Diagnostic Trouble Code (DTC) P107471 - AMT-F

Published 10 July 2024

All vehicles with AMT-F gearbox built built February 2022 - February 2023.

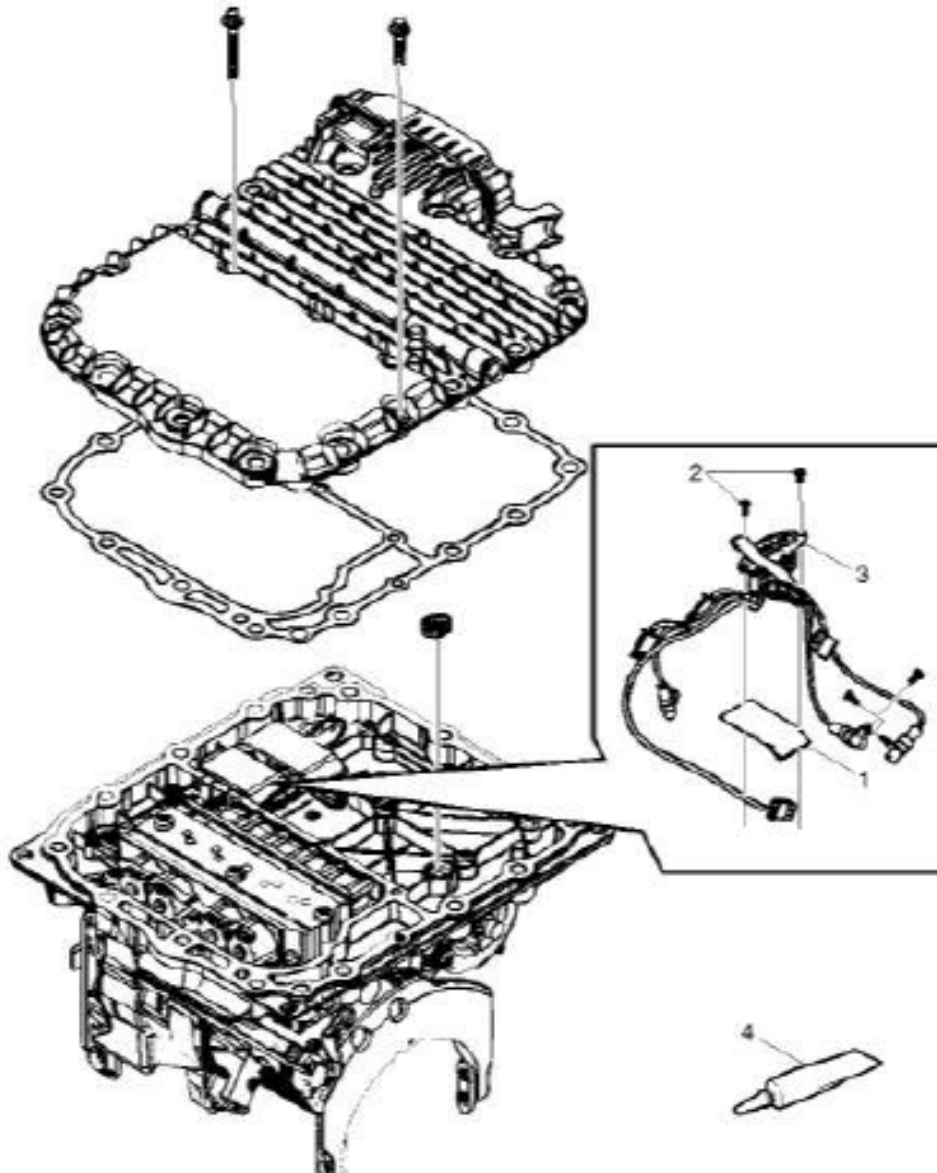
Affected vehicles may experience the following symptoms:

- Transmission stuck in gear or seems to go to neutral momentarily while the transmission selects another gear
- Grinding gear shifts
- "CHECK TRANS AT NEXT STOP"- message in instrument cluster
- Check Engine Light active (Other shifting faults may be set but at a much lower occurrence)

1. Replace "Pass-through; kit, speed sensor included".
2. Replace position sensors 2/3 (A) and Split (B) (P/N - 20562642)

For some vehicles, the transmission needs to be removed to access control housing.
